SUBJECT: REVIEW OF REVISED LONG-TERM SURVEILLANCE PLAN FOR THE U.S.
DEPARTMENT OF ENERGY CANONSBURG URANIUM MILL TAILINGS
DISPOSAL SITE, CANONSBURG, PENNSYLVANIA (TAC J00542)

**TECHNICAL EVALUATION REPORT
CANONSBURG URANIUM MILL TAILINGS DISPOSAL SITE
LONG TERM SURVEILLANCE PLAN REVISION**

Figure 3
Tract Map
Canonsburg Site (from DOE, 1995)

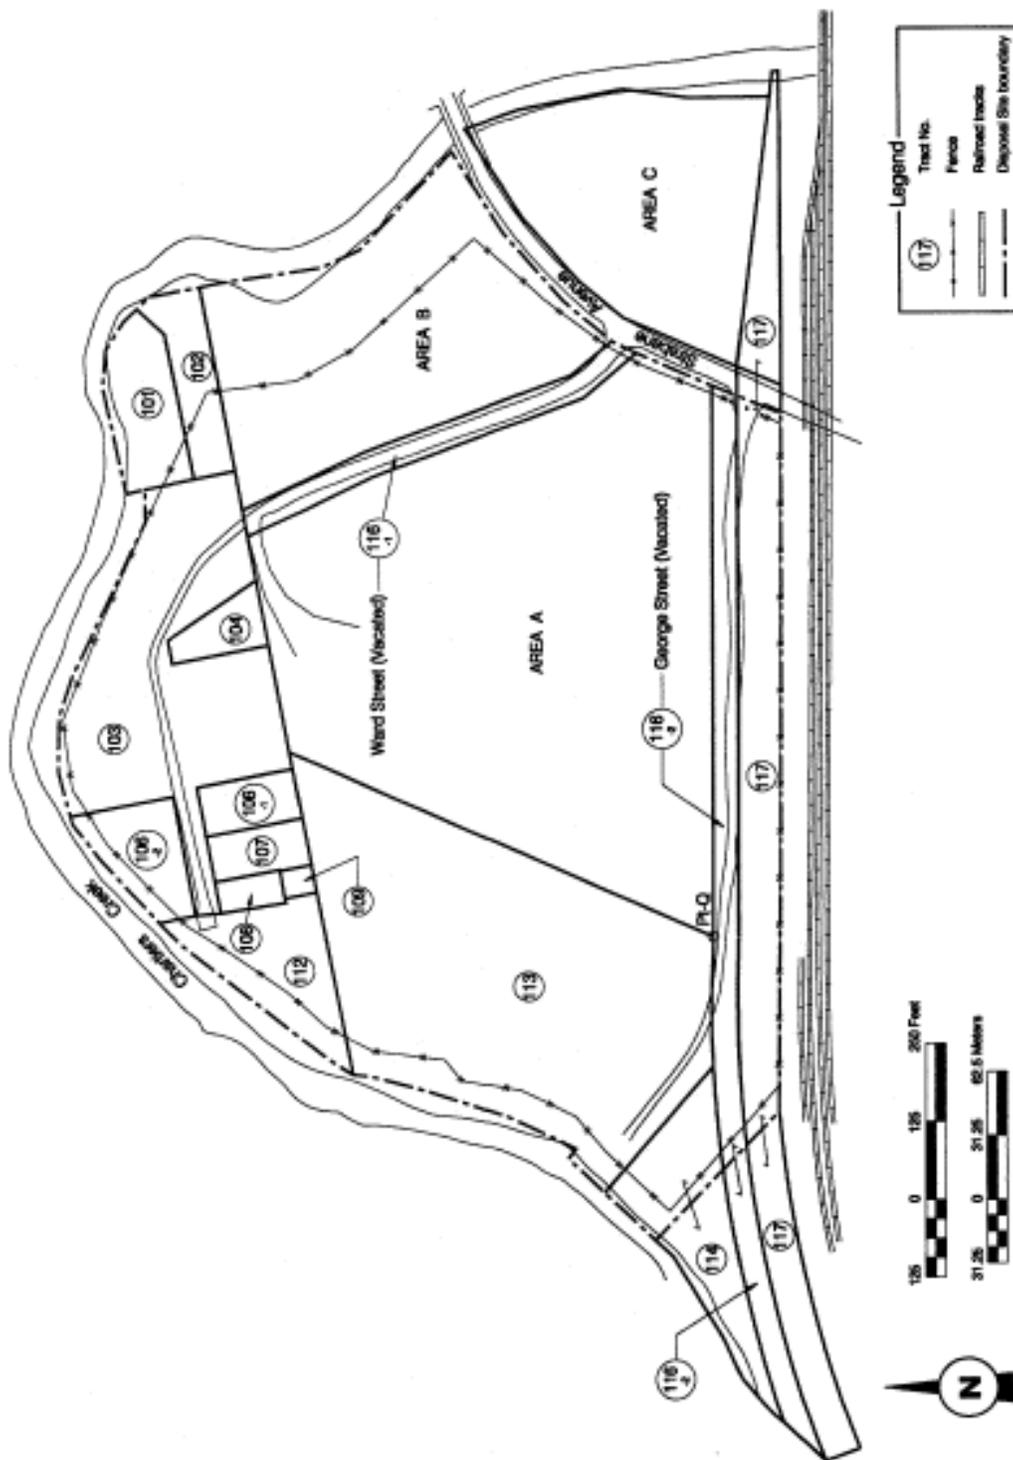
In the cover letter submitted with the revised LTSP, DOE indicated that the changes related to deed restrictions and inspection practices were made in support of the potential sale of Tract 117-E at the Canonsburg site. As shown on Figure 3, Tract 117 lies parallel to the railroad tracks on the southern side of the site. Tract 117-E is the portion of Tract 117 that lies east of Strabane Avenue. The potential sale would only be for Tract 117-E, which is bounded by Area C to the north, Chartiers Creek to the east, a set of railroad tracks to the south, and Strabane Avenue to the west. Tract 117-E is located outside of the security fence at the Canonsburg site. The remainder of this section discusses the history of Area C and Tract 117-E before addressing the specific changes to the LTSP. Note that Area C was generally considered to include Tract 117-E.

The designated disposal site at Canonsburg consists of Areas A, B, and C. During the remedial action process, DOE identified additional "non-designated" parcels that were adjacent to Areas A, B, and C that would need to be acquired. Tract 117-E is a portion of Tract 117, which is one of the "non-designated" parcels. The United States Army Corps of Engineers acquired the additional "non-designated" parcels in the name of the United States of America. Figure 3 shows all of the parcels at the Canonsburg site. A list of the additional "non-designated" properties is provided on Table 1.

Remedial actions in Area C and Tract 117-E included removal of contaminated soil to the disposal cell located in Areas A and B. Clean fill was then brought into Area C and Tract 117-E and the area was regraded. These activities are documented in DOE's Completion Report for the remedial action at Canonsburg (DOE, 1986). NRC staff reviewed DOE's completion report for the remedial action at Canonsburg and documented its findings in a Completion Report Review (NRC, 1995). In the Completion Report Review document, NRC staff noted that DOE performed the remedial action in accordance with the Ra-226 cleanup criteria provided in the Remedial Action Plan (RAP) and that the criteria was established in a manner that accounts for the gradual in-growth of Ra-226 as a result of the Th-230 decay over 1000 years.

In the September 2008 version of the LTSP, DOE indicates that the same deed restrictions identified above will be used for any future Canonsburg parcels that are sold. This would include the Tract 117-E parcel.

Note that deed restriction number 3 for Tract 117-E will be changed slightly to allow for access to monitor well MW-414.

DOE has also indicated that it will continue to inspect Tract 117-E in the same manner that Area C is currently inspected. This would include comparing the observed site conditions to verify that the site owner is complying with the deed restrictions. The annual inspection would also include examining Tract 117-E for evidence of erosion, settlement, changes along the stream bank, or any other changes that may impact the long term performance of the site.

The NRC has completed its review of DOE's revised LTSP for the Canonsburg site. This included a review of the documentation related to completion of the remedial action at the Canonsburg site. The Completion Report Review (NRC, 1995) addressed the Th-230 anomaly in Area C and concurred on the completion of the remedial action at Canonsburg. Additionally, the combination of clean fill overlying the thorium anomaly and deed restrictions related to property use, excavation and monitoring for radon provide adequate protection against exposure to radon. Therefore, the staff considers the proposed changes to the LTSP, which support the sale of Tract 117-E to be protective of public health and safety, acceptable. Accordingly, the NRC hereby accepts the Revised Canonsburg LTSP dated September 2008.
